SHOREHAM NUCLEAR POWER STATION - UNIT 1
EMERGENCY DIESEL GENERATOR DR/QR PROGRAM
DOCUMENT REVIEW TRANSMITTAL

- ☐ Component Design Review Checklist/Task Description No. DR-
☐ Component Revalidation Checklist/Task Description No. QR-
☒ Component Task Evaluation Report (TER) No. Q-465
03-315A

TER # Q-465

COMPONENT TASK EVALUATION REPORT

CYL #5
HOLE #3 & 6

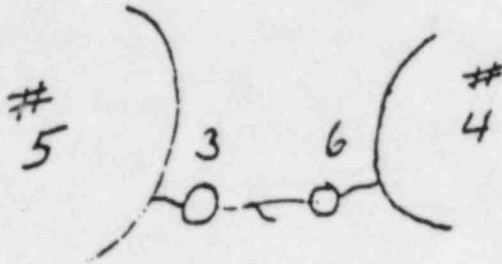
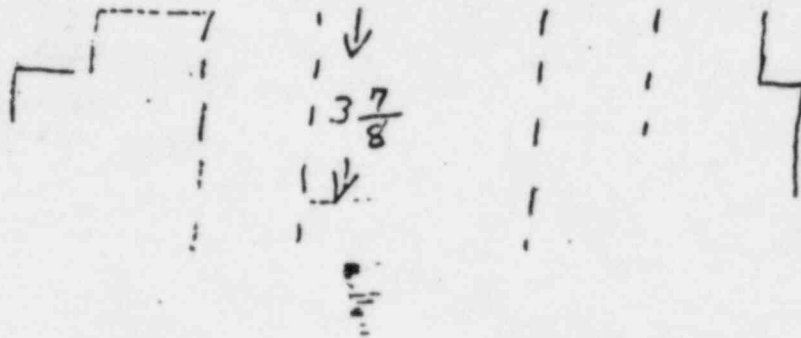
IS IT $2\frac{1}{2}$ " HERE?
P18/32

CRACK IN
STUD HOLE #3
~~2 3/8~~ 3 7/8

Q-465
22/32

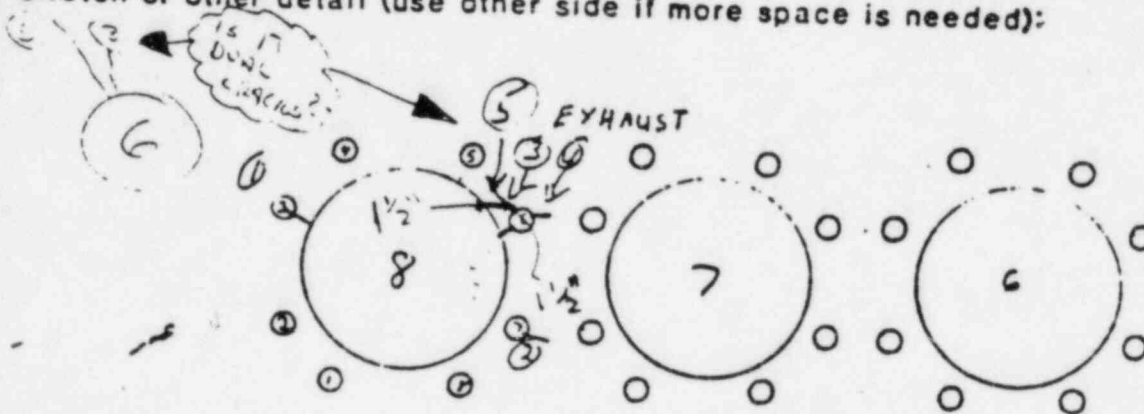
WHAT
TELLING IN
INCHES?
